Service Information

1. Modifications NTSC panel

3. New XICOR

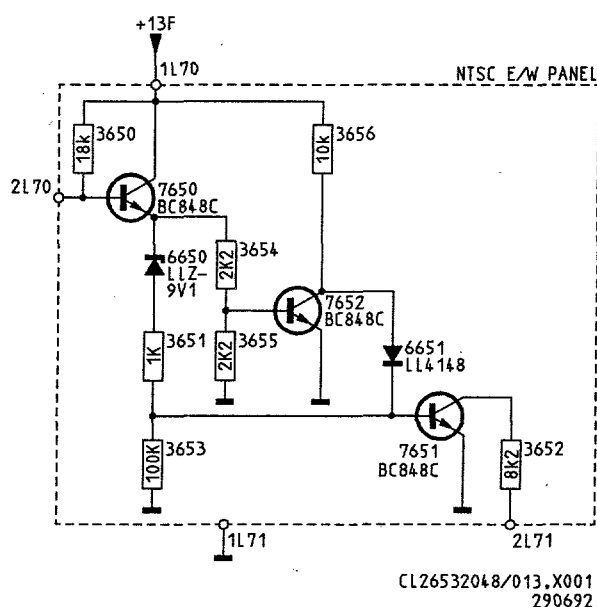
During production position 7137 of the small signal panel has been modified from a X2404 to an ST24C04B1 (4822 209 52316). This modification was introduced in week 9207.

Several other components have also been modified during this modification, some of which were introduced earlier.

Removed

Positions 3256 and 3257 (not for < AG04)

Modified

Positions 3122 and 3123 (8k2) 4822 051 10822 (not for < AG04)

Added

Positions 3287 and 3288 (10K) 4822 051 10103 (not for < AG04)

Positions 6256 and 6257 (LL4148) 4822 130 80446 (not for < AG04)

Positions 6135 (4702) 4822 051 10471

The addition of position 6135 must occur if 7137 is modified to an ST24C04B1 and may not be present if an X2404 is used.
